Response to Council Letter dated 15<sup>th</sup> June 2021  
DA2021/0412 – 17 Maretimo Street, Balgowlah NSW 2093

Please see below our responses to the preliminary assessment of the application.

Figure 2.  
Maretimo Street – Approximate streetfront setbacks of neighbouring properties

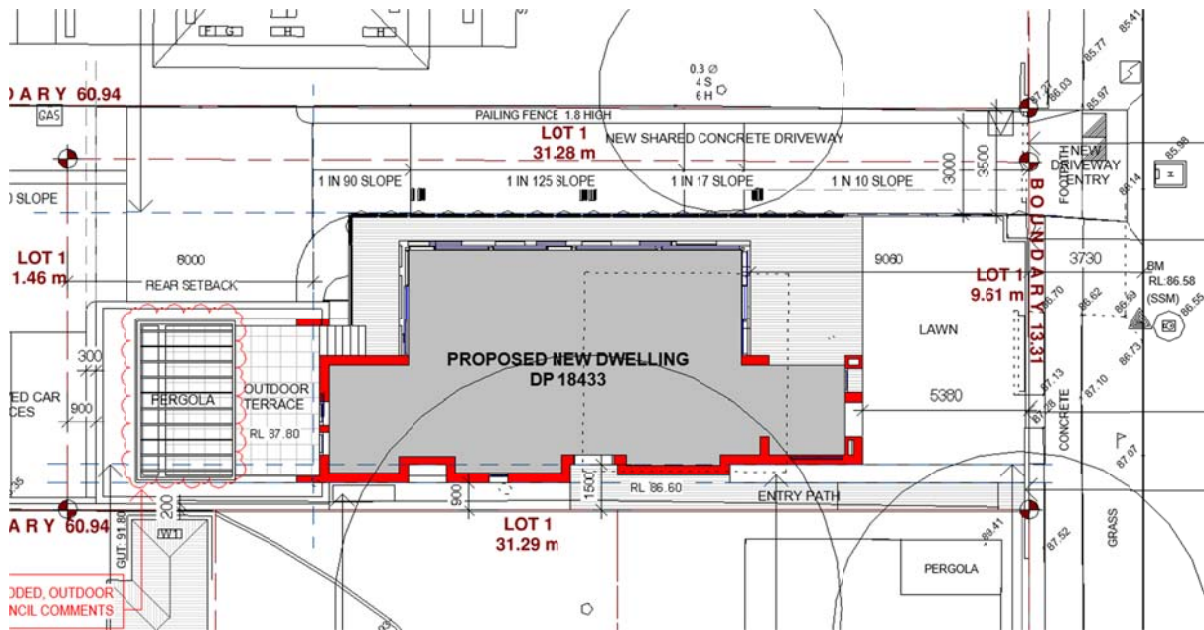
*With a setback of 5.38m to Maretimo Street, the proposal does not comply with the 6m minimum front setback control prescribed by this control. The proposal is inconsistent with the relevant underlying objectives of the control in regards to character of the street and the incompatibility of the proposal with the predominant setback existing in the street.*

The proposed front setbacks – 5.38m & 9.06m – are in line with the DCP controls & existing neighbouring properties prevailing building lines. Refer to Figure 2, approximate street front setback diagram.
